Inspection Report
Minerals Regulatory Program
Report Date October 17, 2005

Mine Name: T&M Holdings
Operator Name: Decorative Landscaping

Permit number: S/035/023
Inspection Date: September 9, 2005
Time: 9:15-9:45 AM

Photo 1.

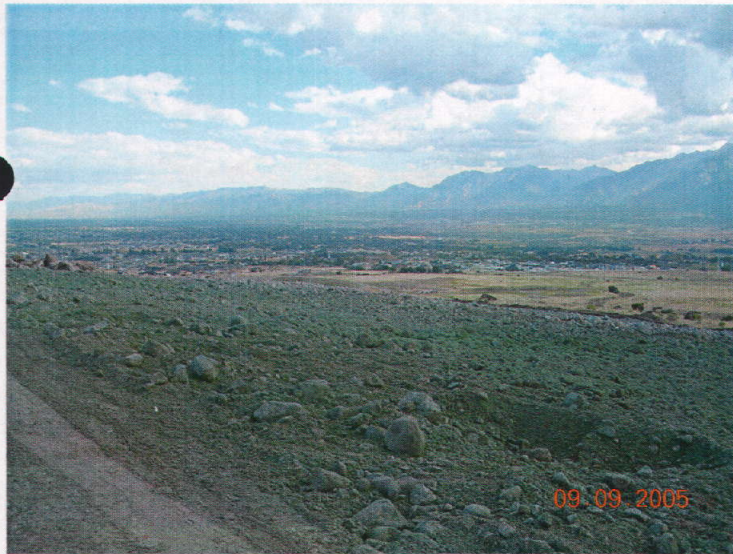
During the inspection, the operator was in the process of hydroseeding the disturbed area (Photos 1-3). Mr. Burnham said the seed mix was one he found on a web site. Fertilizer (25/5/3) was mixed with the slurry, and, as I recall, it was being applied at the rate of 25 pounds/10000 square feet. They are also watering the area in an attempt to accelerate germination.

In the future, I suggest that the operator not use fertilizer. Best results are usually obtained by applying seed and mulch in two separate operations.
